ADDENDUM NO. 1

August 3, 2023

Geiger House
2631 Gilbert Avenue
Cincinnati, OH 45206

Emboss Design (formerly PCA)
906 Monmouth Street
Newport, KY 41071

EXTERIOR ELEVATIONS

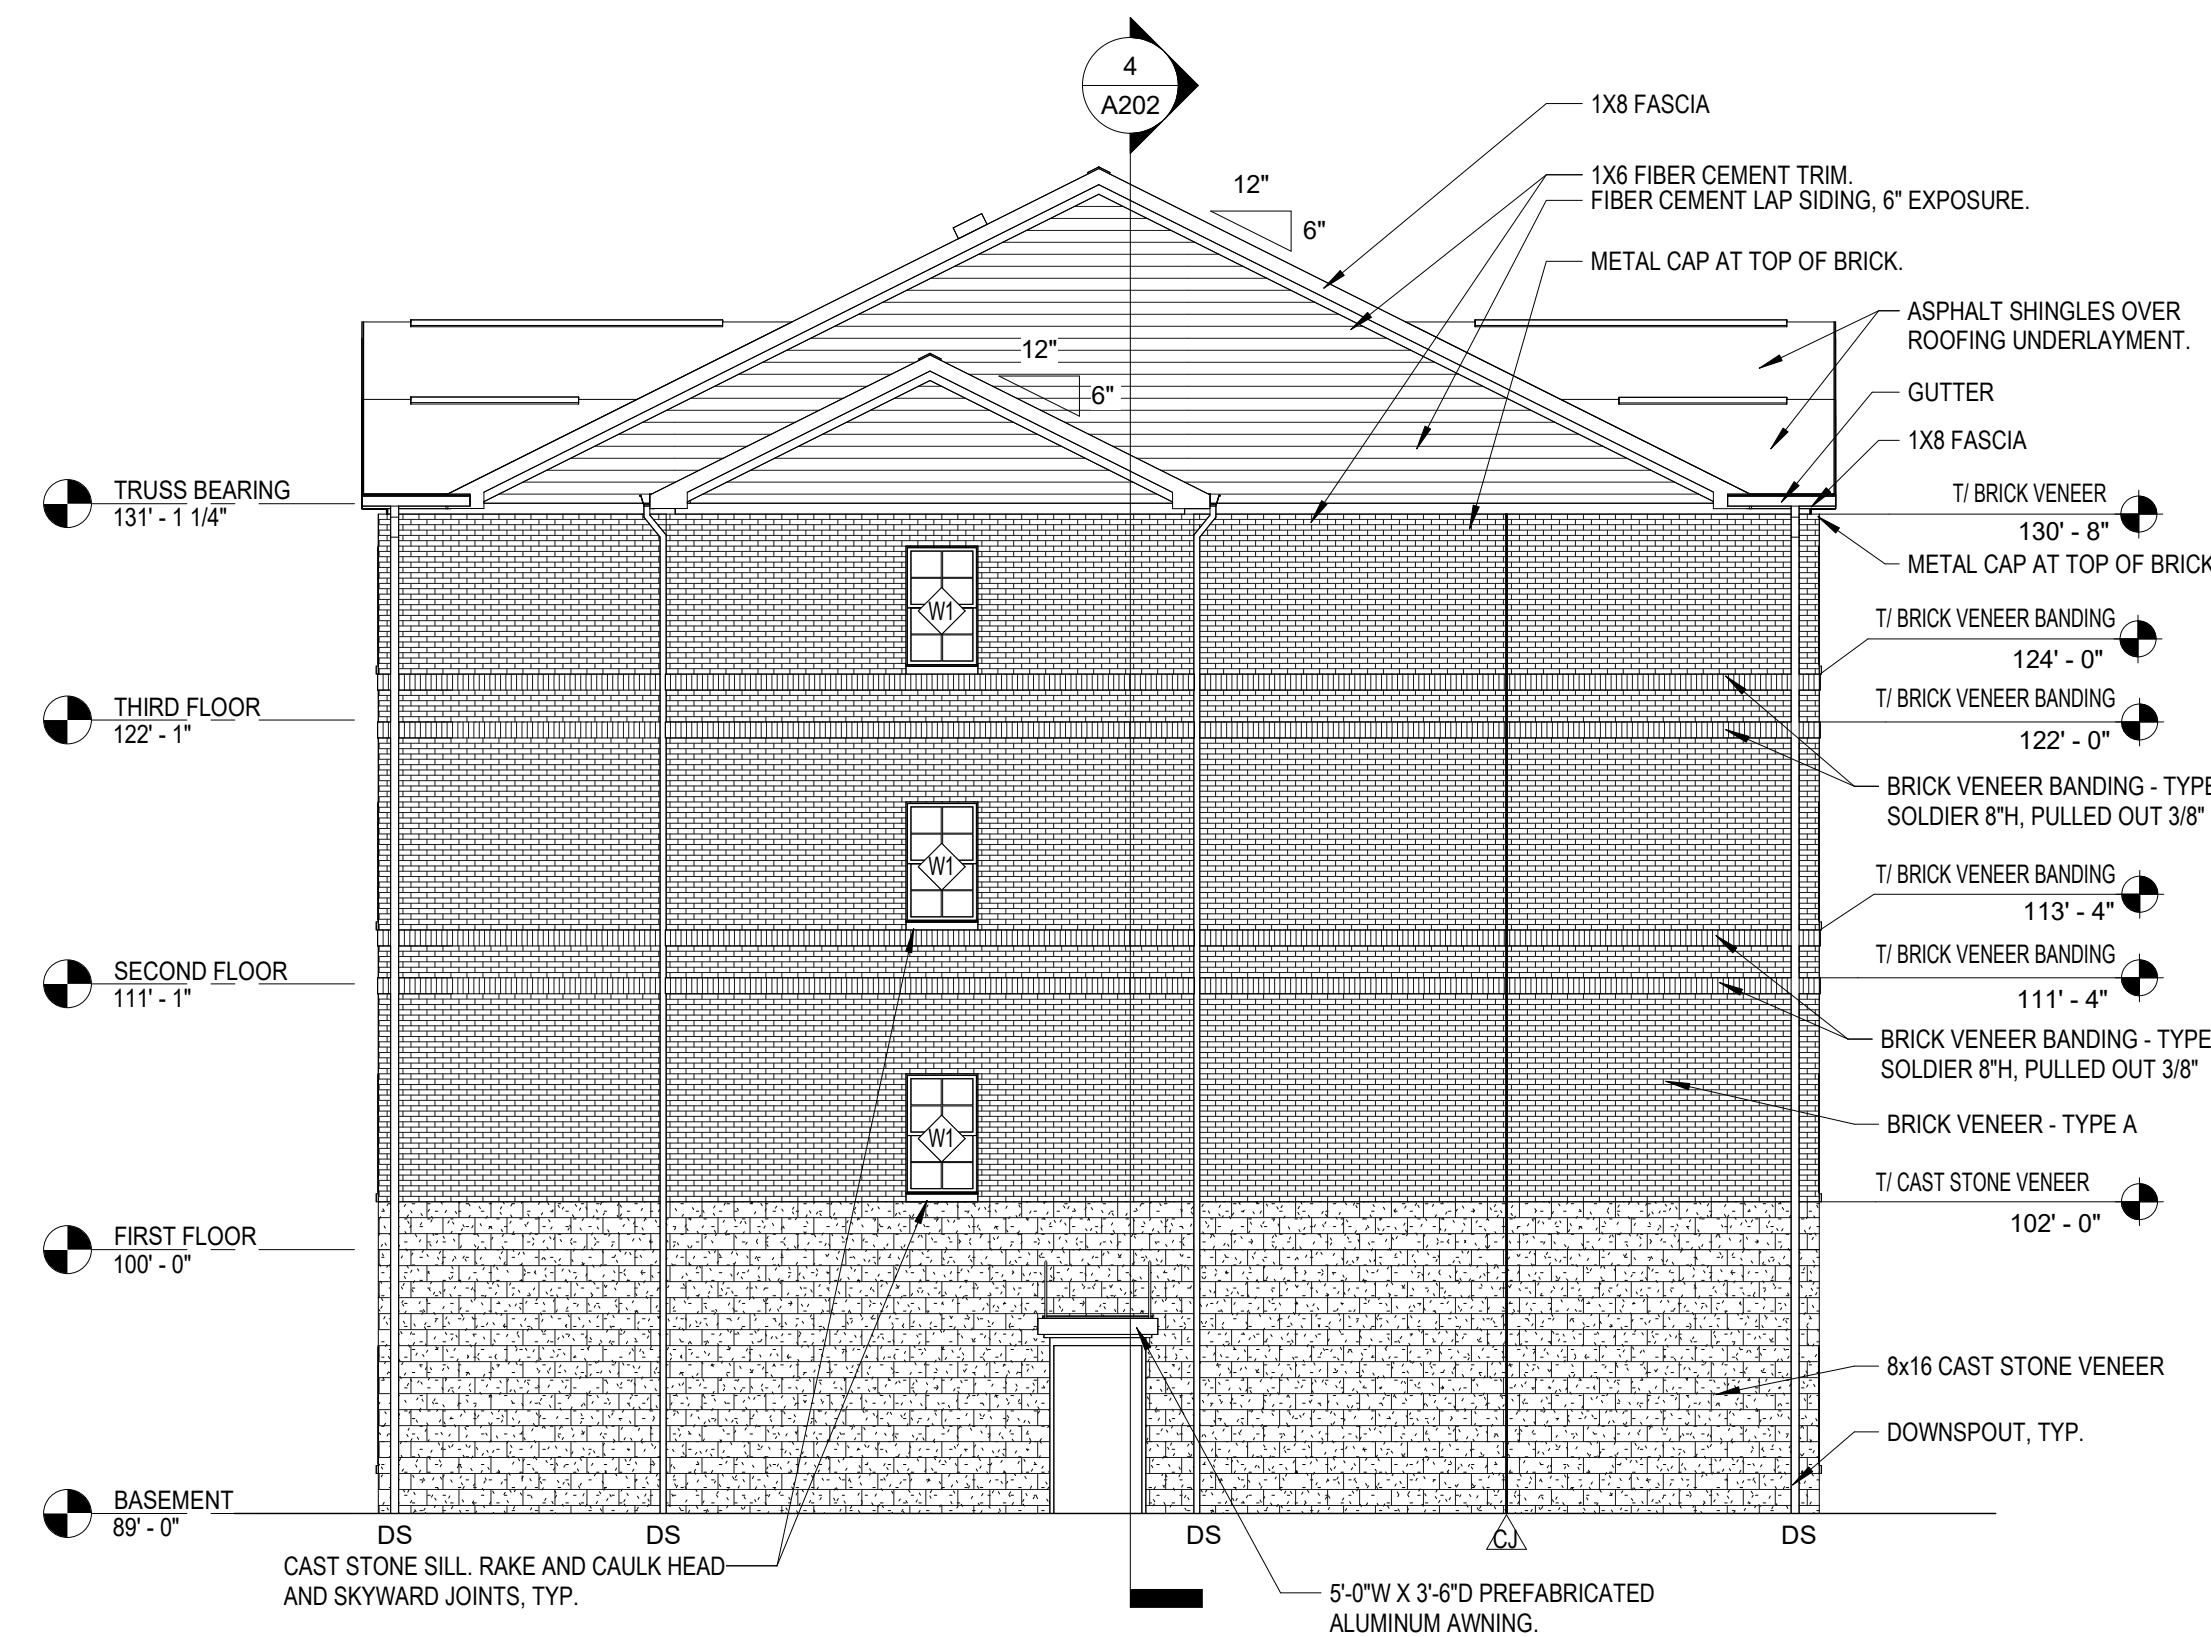
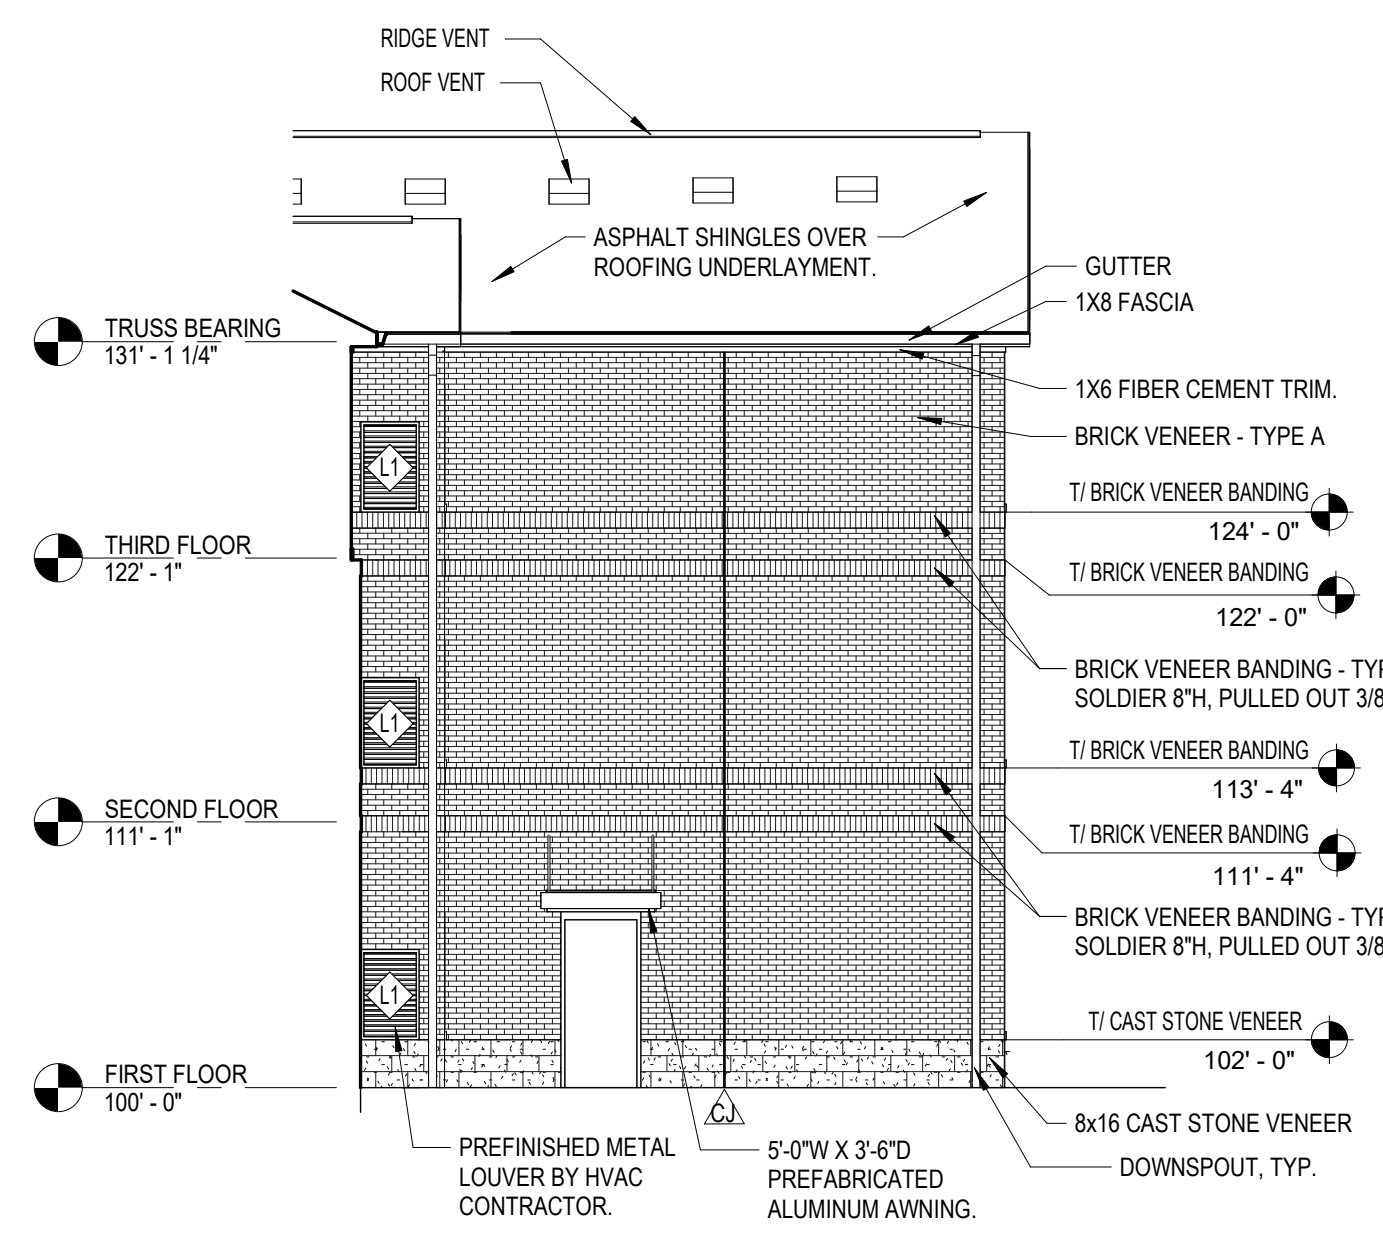
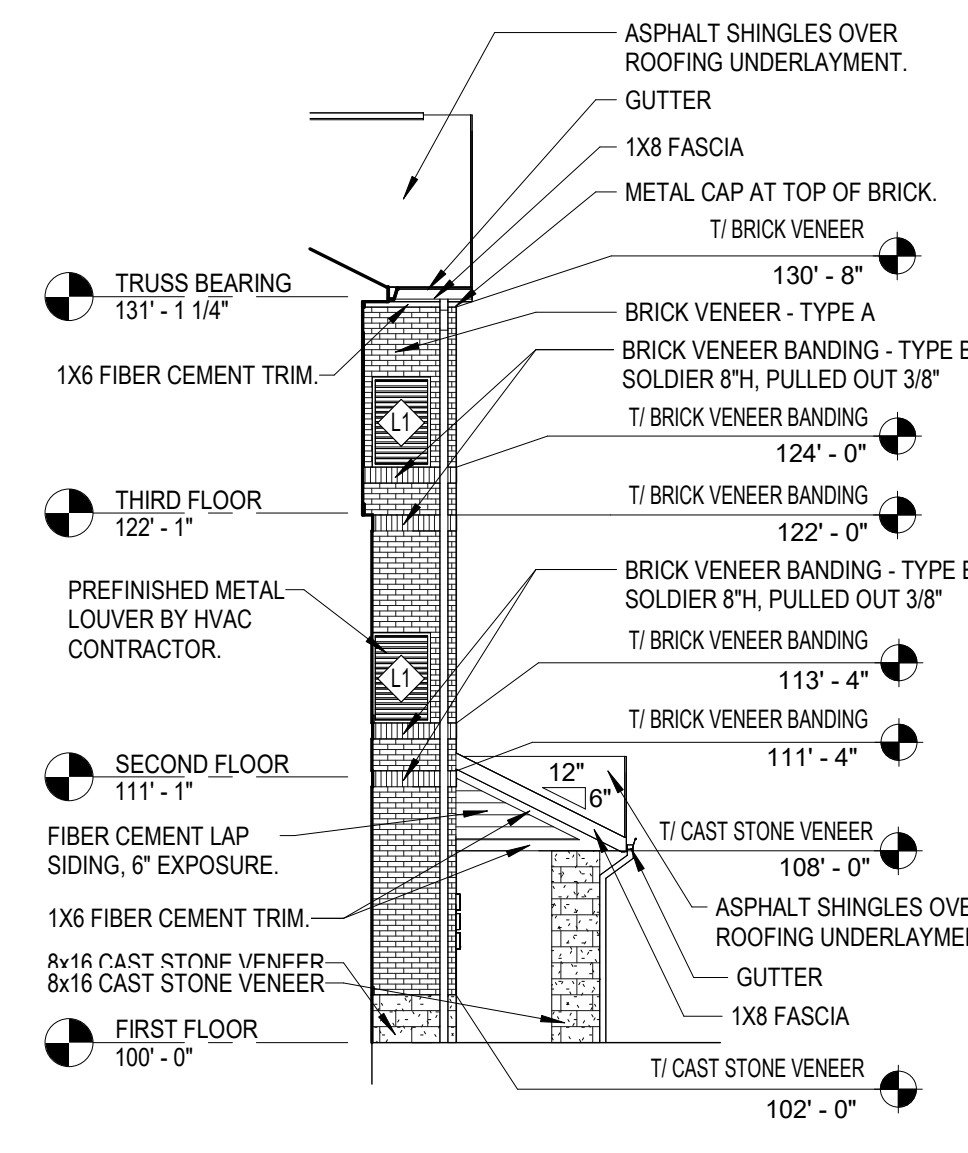
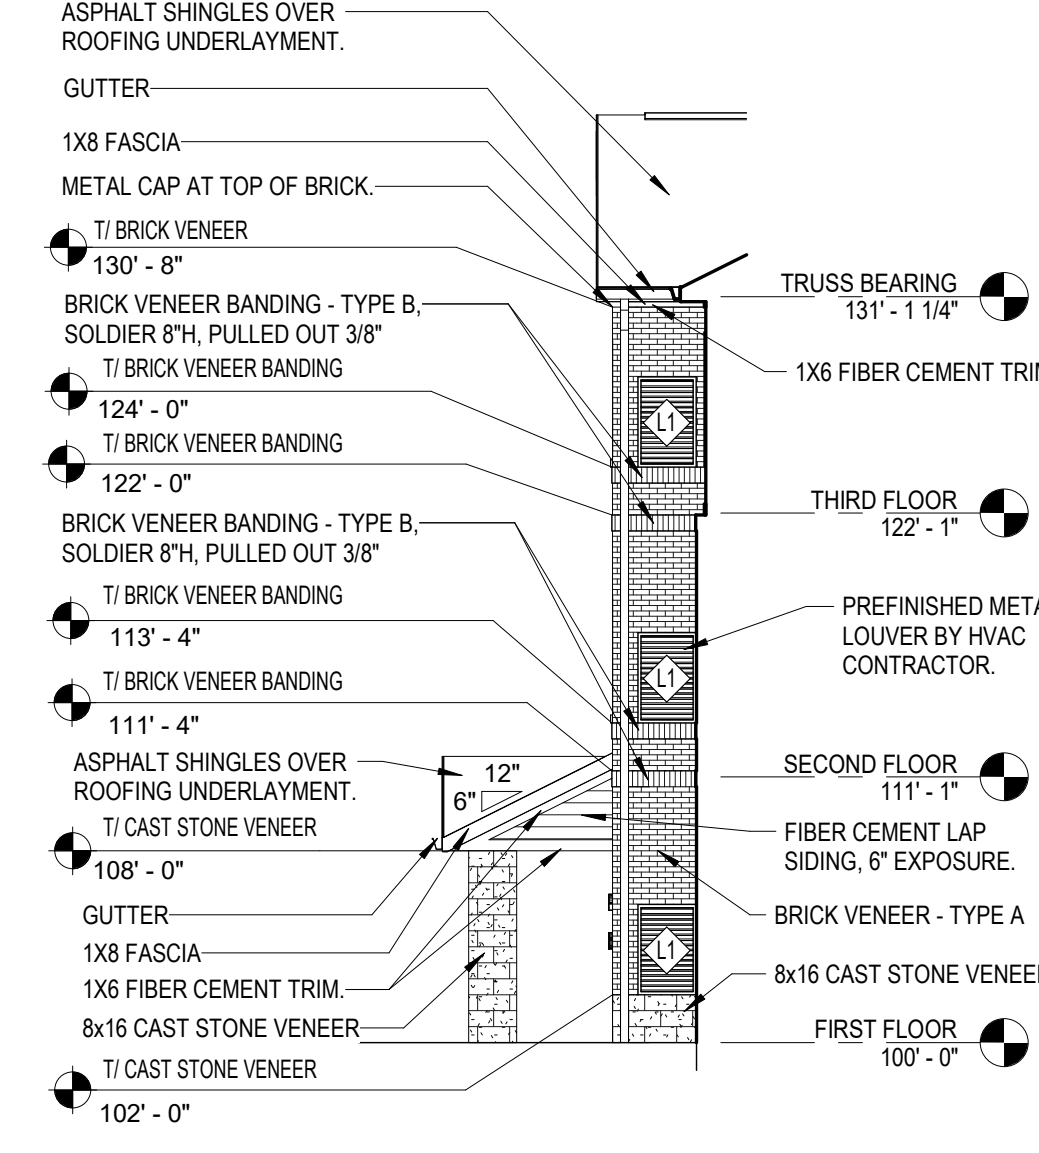
4. A201 EXTERIOR ELEVATIONS

- Removed Window W2 under front entry porch and added dimension letters where window previously shown.
